Ann Arbor Historic District Commission Staff Report

Address: 511 West Jefferson Street.

Application Number: HDC26-0064.

Application: The applicant seeks HDC approval to add a basement egress window near the front of the house and to remove and replace a non-original basement window in the existing opening, both on the west elevation.

SIDE ELEVATION (WEST) - PROPOSED
SCALE: 5/32" = 1'-0"

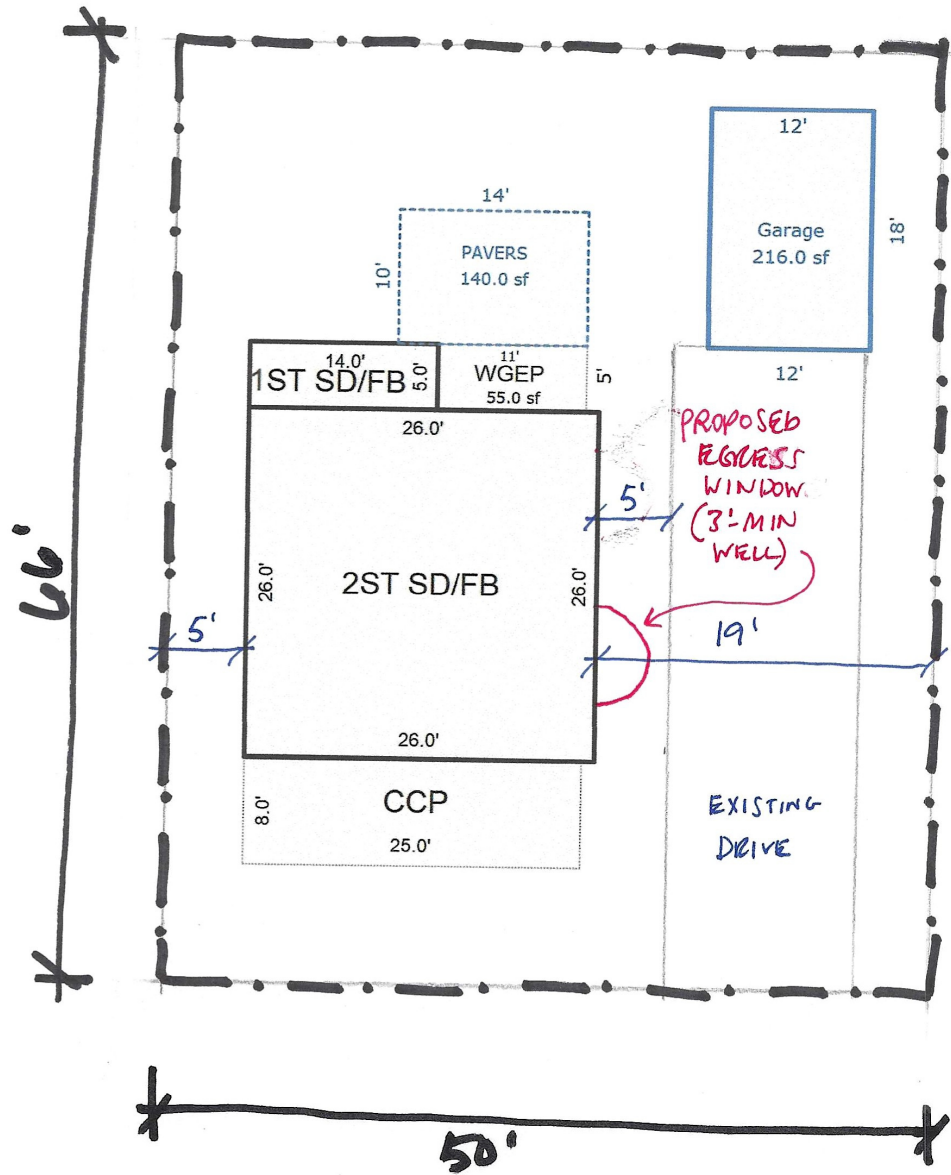
1. The applicant proposes a new egress window well on the east elevation near the front of the house. It will be a composite casement window that matches the width of the existing opening in this location, which measures 32 in wide. The window well will be curved and will extend 3ft from the building plane. It will be composite.

This proposed location must be approved by the Commission because of its proximity to the front elevation.

2. The applicant also proposes to remove and replace the existing basement awning window on the west elevation closer to the rear. It will be replaced in the same opening with a composite awning window.

The window should be inset to the same plane as the current window glass, and a condition is included in the suggested motion.

BASEMENT PLAN - PROPOSED
SCALE: 1/8" = 1'-0"

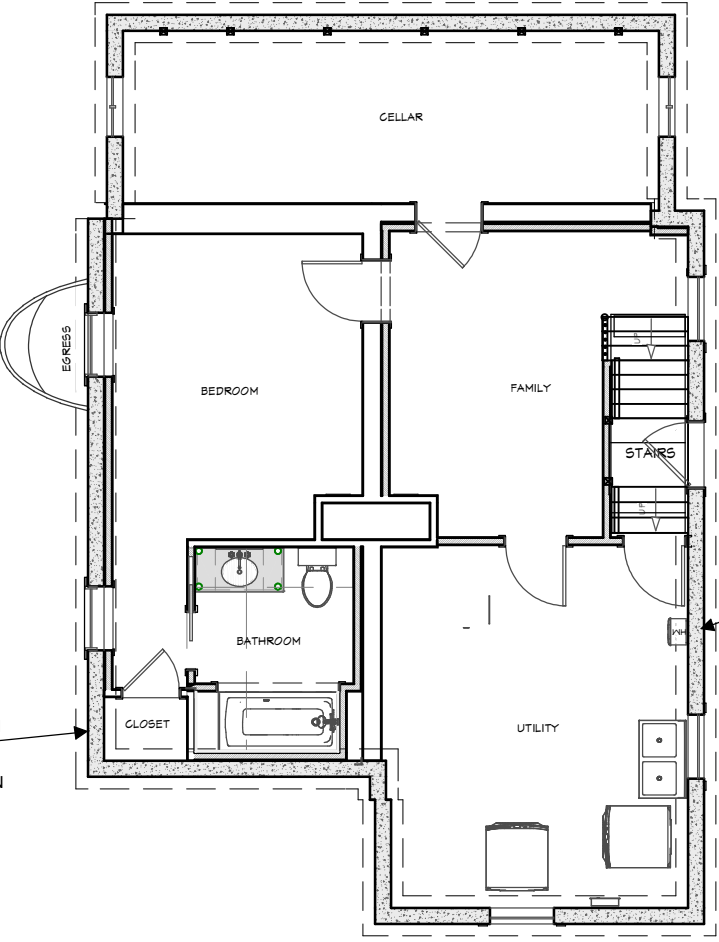
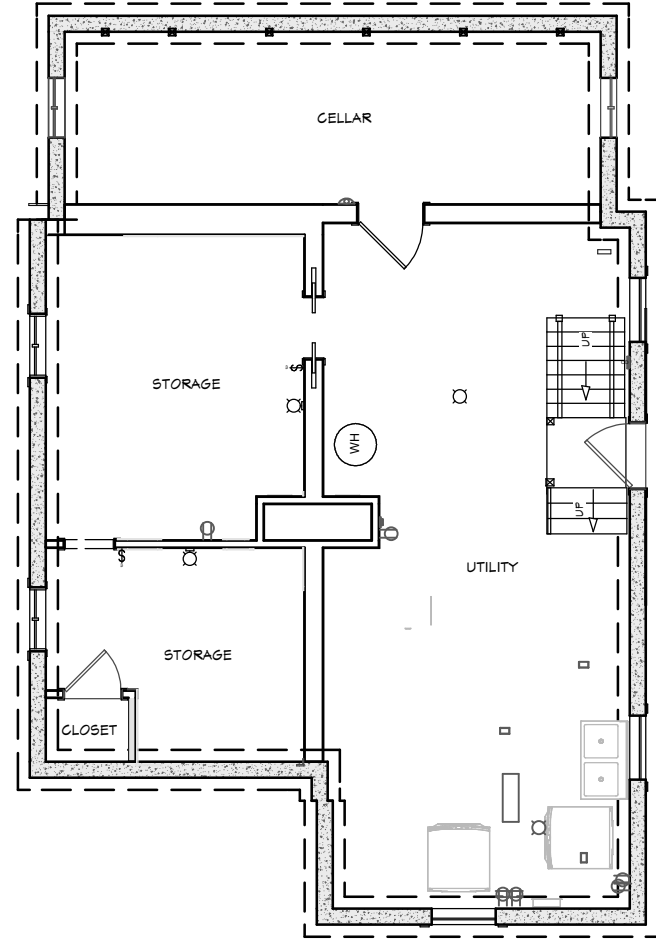
3. Also included in this application are two new penetrations for mechanical systems, one on the east elevation and one on the west elevation. Both will be near the rear of the house, located within the non-original foundation, and not visible. These penetrations could be approved by staff but are included here to consolidate the number of Certificates of Appropriateness.
4. New basement egress windows are often necessary in historic buildings to meet contemporary building codes. Based on the drawings and earlier iterations of the design, it would be possible to convert the window closer to the rear on the west elevation into an egress window. This would be a more appropriate location because it would be less visible and farther from the character-defining front elevation. The applicant proposes this location near the front of the house for more light and air in the basement bedroom.

Because of stairs and mechanical equipment on the east side and rear of the house, locations on other elevations are not possible.

NEW WINDOWS

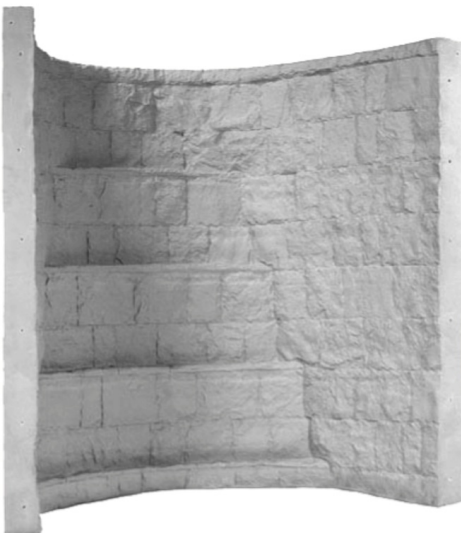
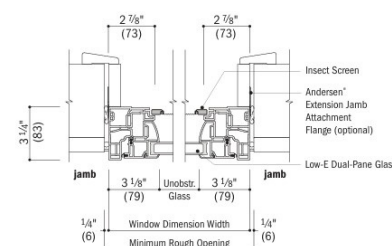
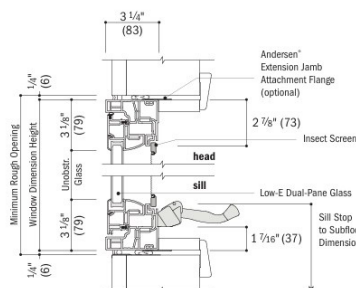
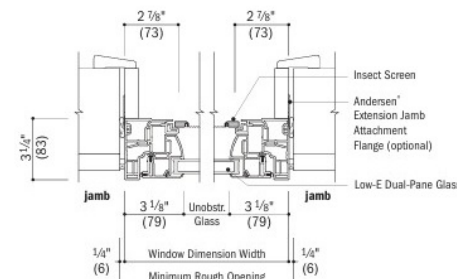
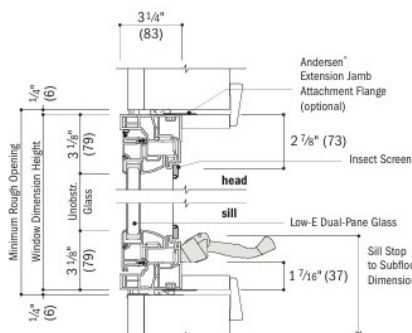
5. This is the first time that the Commission is considering composite as a material for a basement egress window and well and for a replacement basement window. Regarding the rear basement window on the west elevation, staff can approve the replacement of non-original windows with compatible windows. Replacing with an awning window in the same opening is a compatible design, but the Commission must decide if composite is an appropriate material for basement windows.
